FARRAGUT MUNICIPAL PLANNING COMMISSION

AGENDA

April 18, 2024

SUBJECT: Request for approval for the installation of six inch Medium Density Polyethylene (MDPE) pipe along a section of the south side of Kingston Pike east of Little Turkey Creek Commons to and along a portion of the west side of Old Stage Road and two inch MDPE from Old Stage Road to Windham Hill Road and from Old Stage Road along a short section of the north side of Somersworth Drive just past the intersection with Gwinhurst Road (KUB, Applicant)

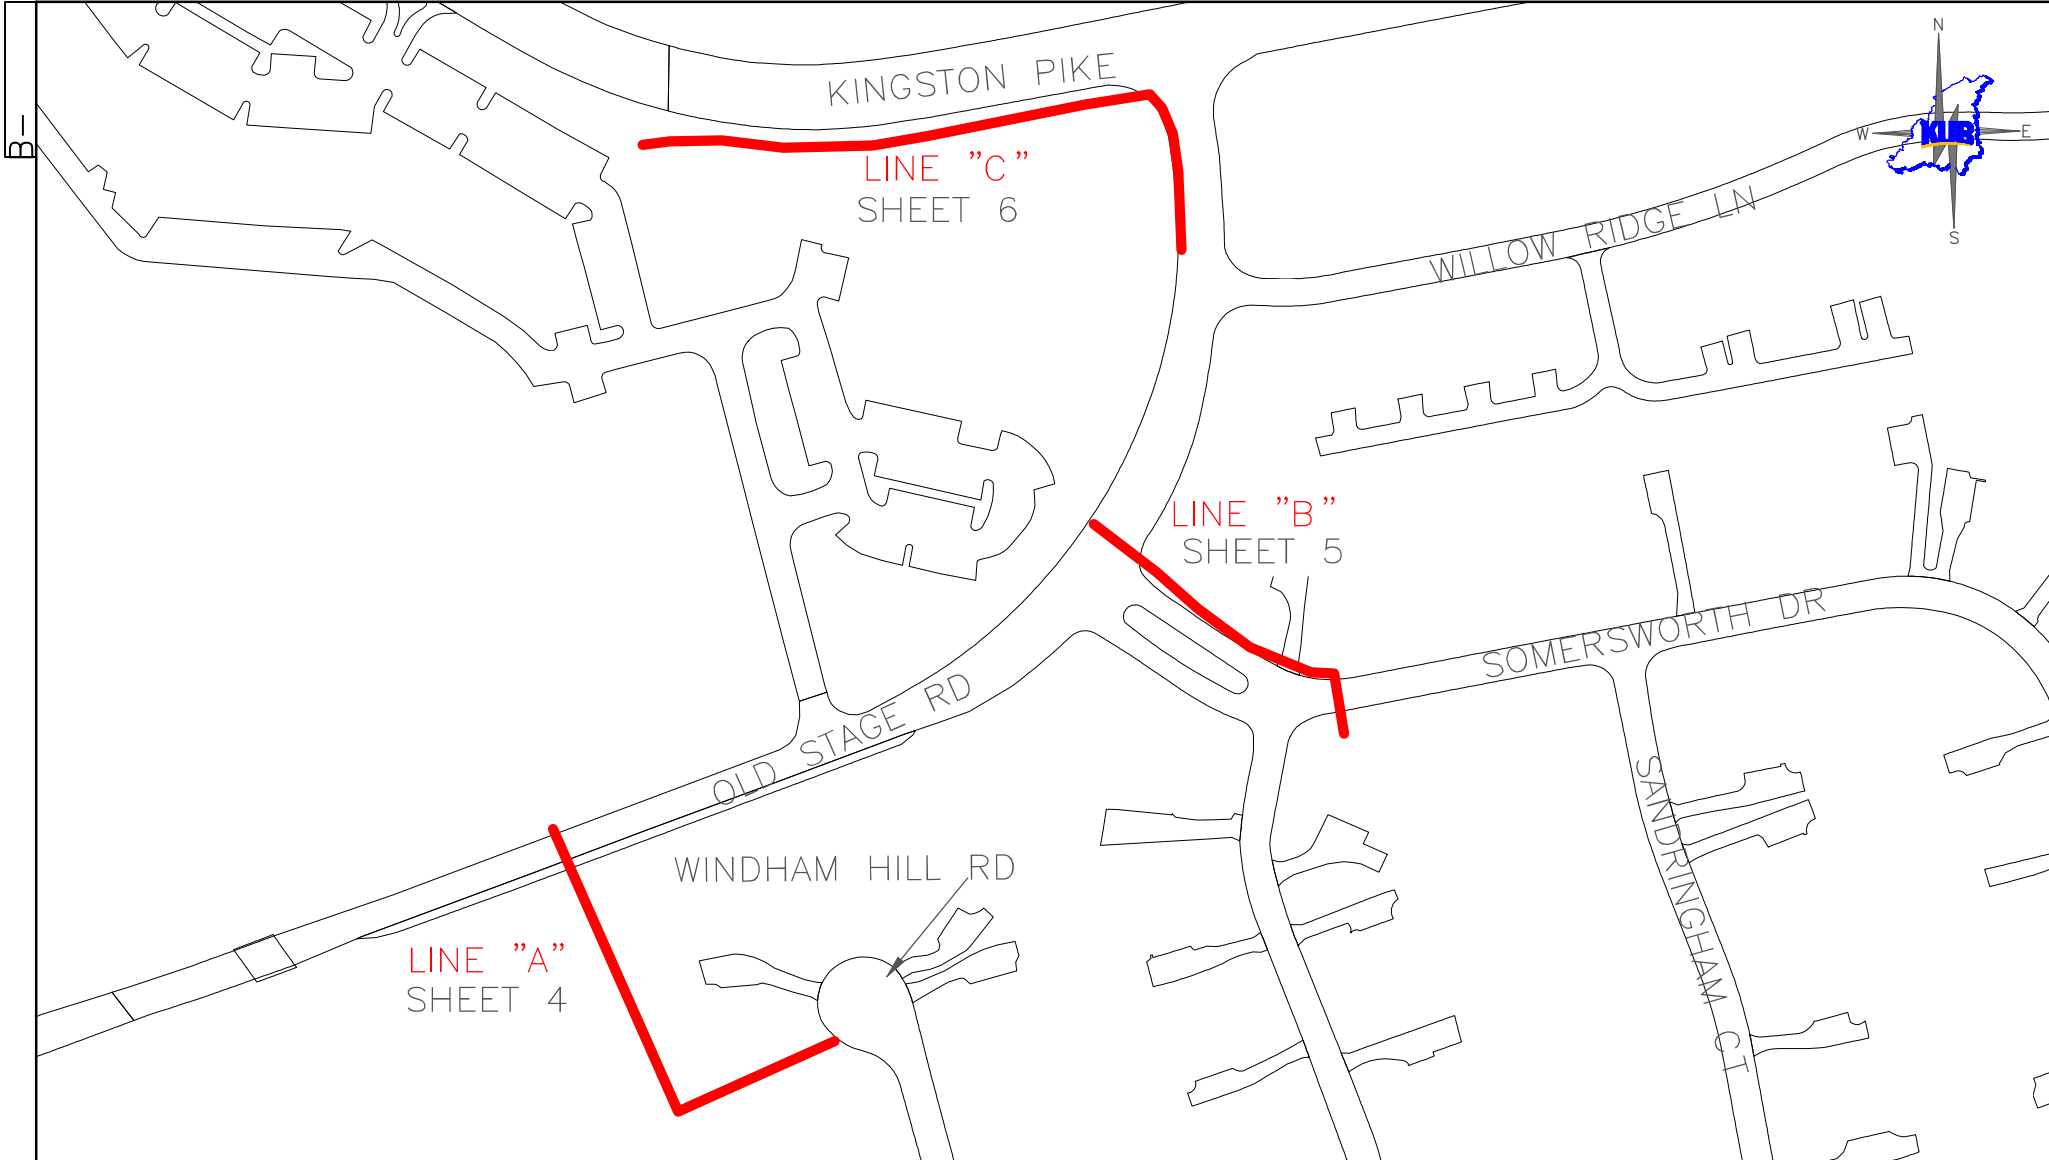
DISCUSSION: The proposed installation will be performed by KUB and the only open cutting will be at tie in locations. KUB will be obtaining a permit from TDOT for working in the Kingston Pike right of way and will coordinate work with the Town's engineering department through a right of way permit. Any areas that are disturbed will be required to be restored to their previous condition. KUB will also coordinate traffic control with the Town's engineering department.

RECOMMENDATION: The staff recommends approval subject to the following items being addressed:

- 1) Please obtain a right-of-way permit from the Town's Engineering Department, including erosion and traffic control measures and inspections, as needed.
- 2) Please notify all affected property owners prior to the work being initiated.
- 3) Please obtain an access permit from TDOT.
